1 d) Structure

Heritage Council Comment 1 d)

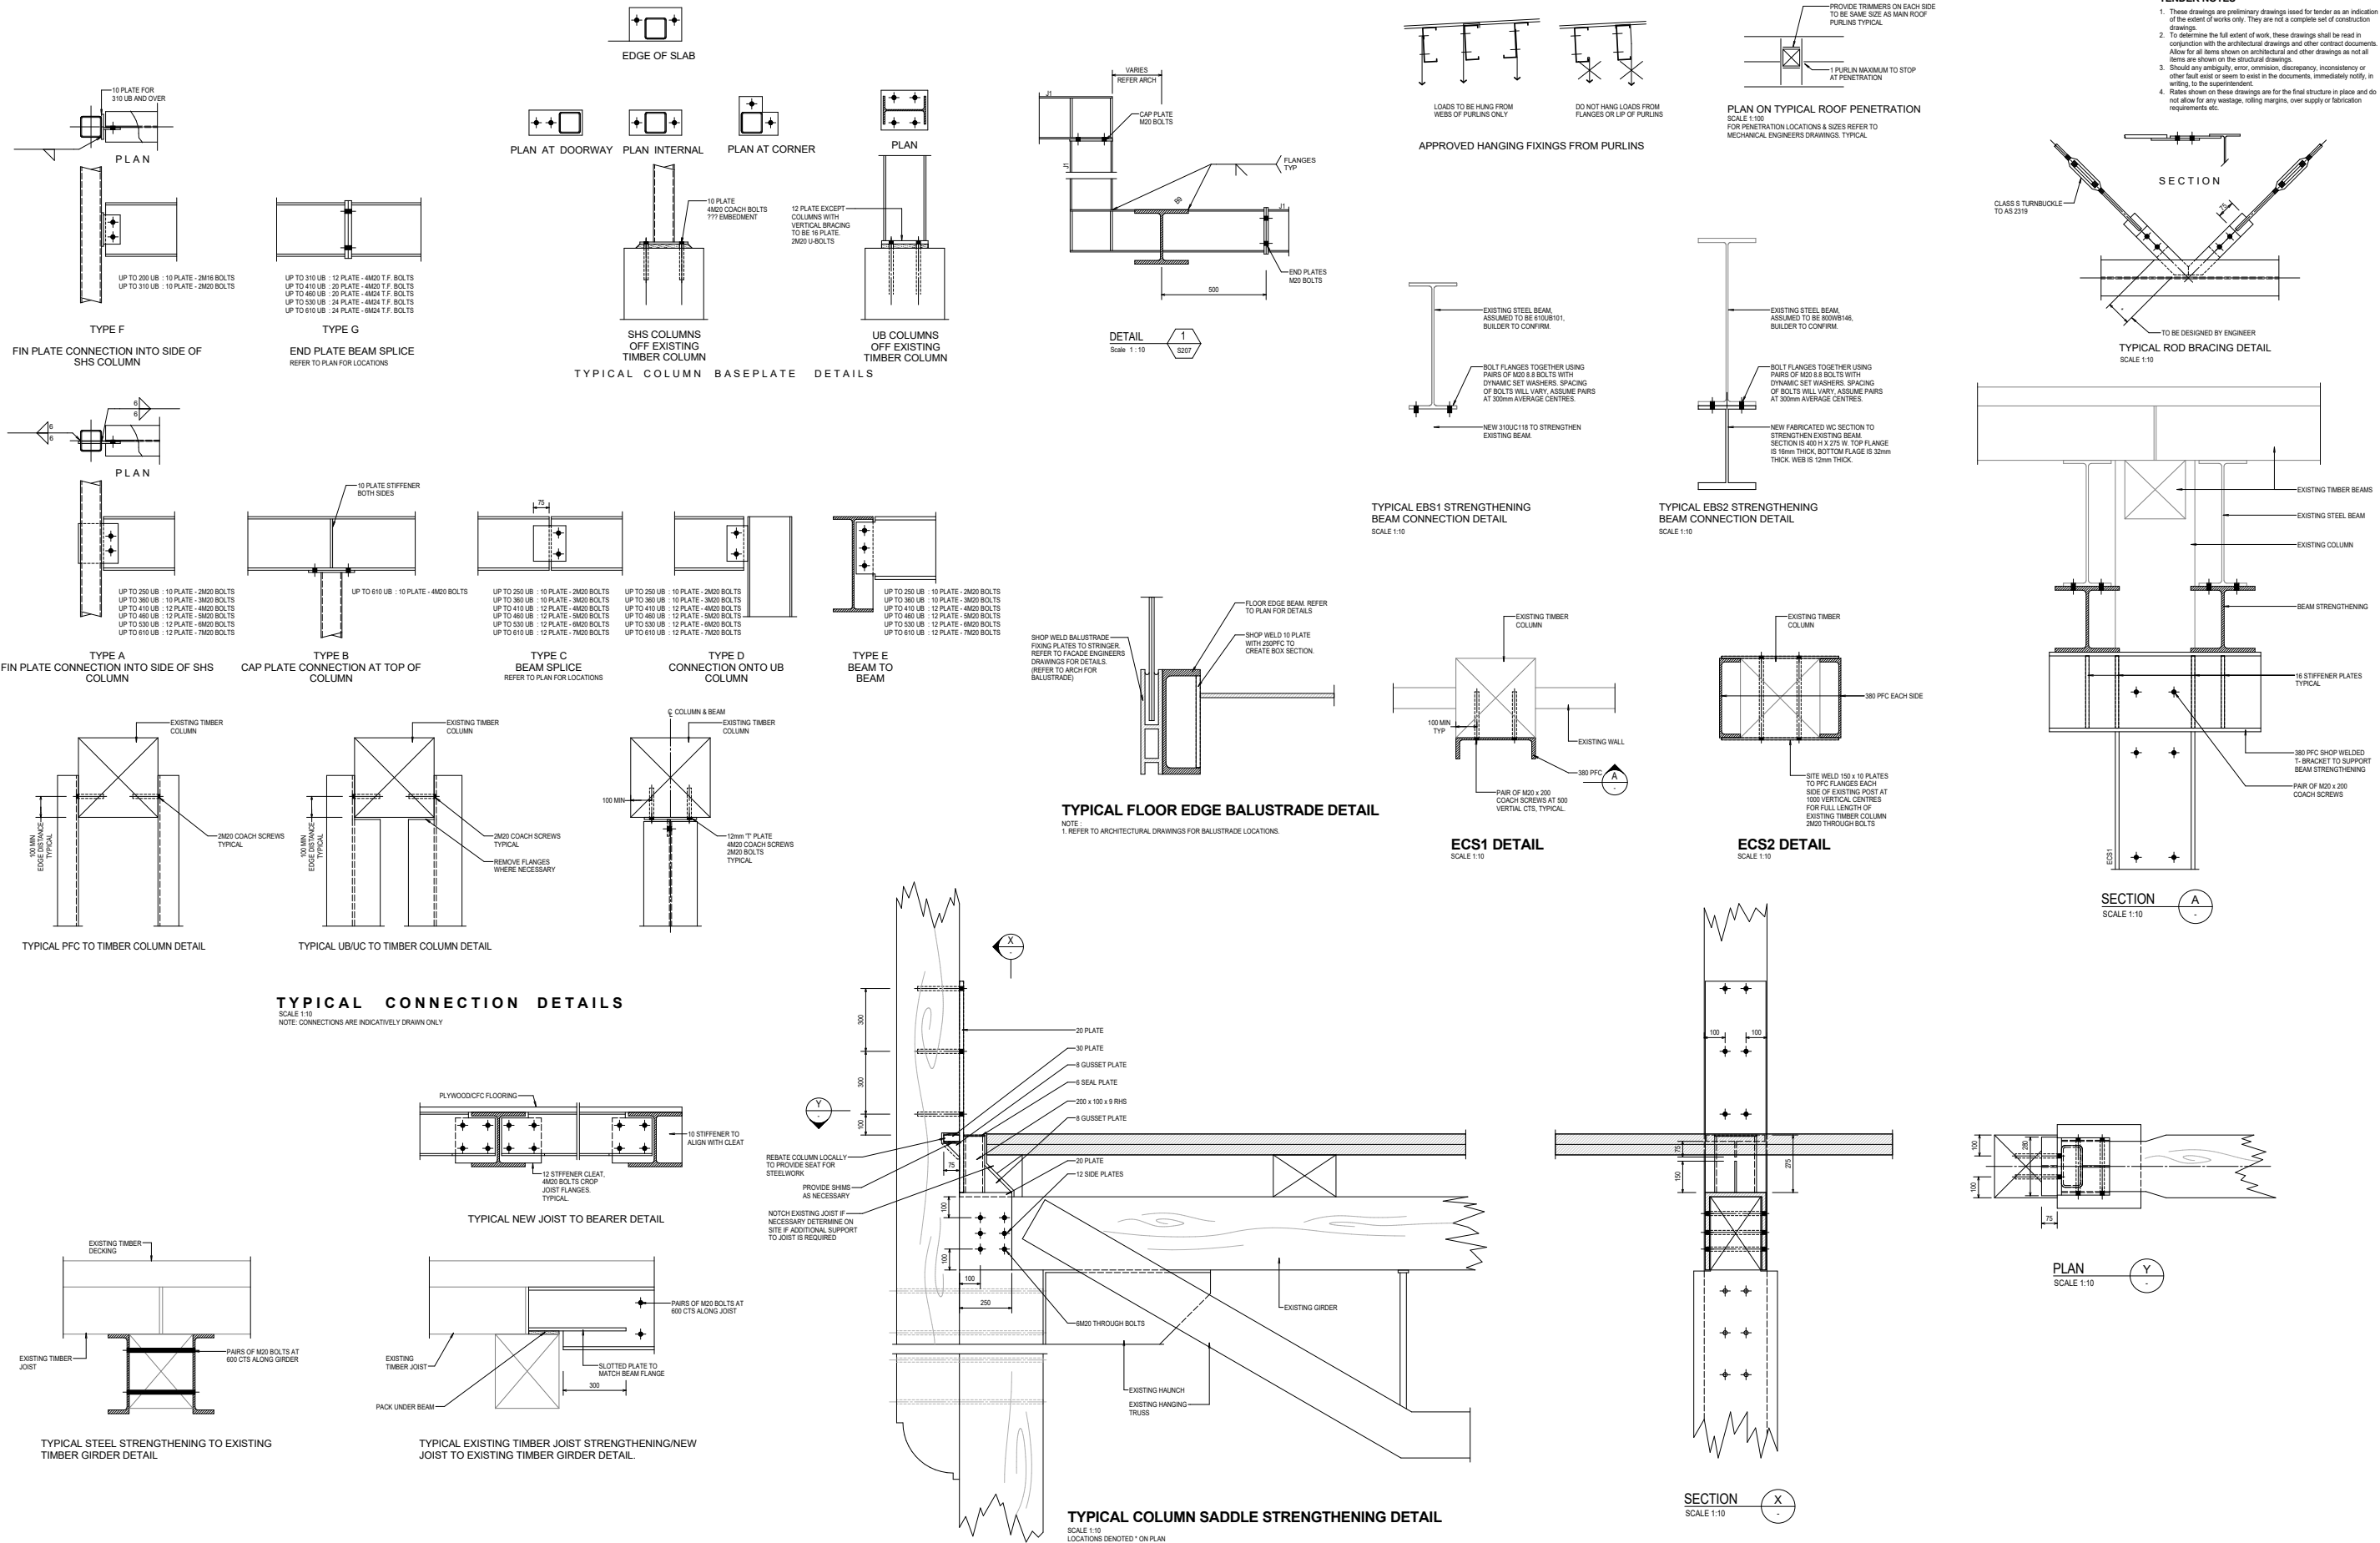
Limited information has been provided regarding the proposed strengthening of the structure to accommodate new performance spaces and mechanical services. The introduction of new structural members must be undertaken sensitively and with minimal impact to significant fabric and spaces. Further design details must be provided to the Heritage Council for assessment prior to approval of this project.

While the piers were originally designed to take heavy loads, some structural strengthening is required to accommodate the new uses. This is proposed to be undertaken in a sensitive manner, to minimise impact on significant fabric and spaces. Where strengthening is required, new steel beams are typically paired about the original structure, with the new structure clearly identifiable. This approach has already been implemented within Pier 2/3 and Wharf 4/5 and is proposed to be continued for the new work. Structure associated with new mezzanines will be independent and reversible.

Structural solutions will be adopted based on the most minimalist impact on the existing structure and heritage fabric. Existing structure will be sensitively re-used where possible, and all new structure will be detailed to compliment and express the existing.
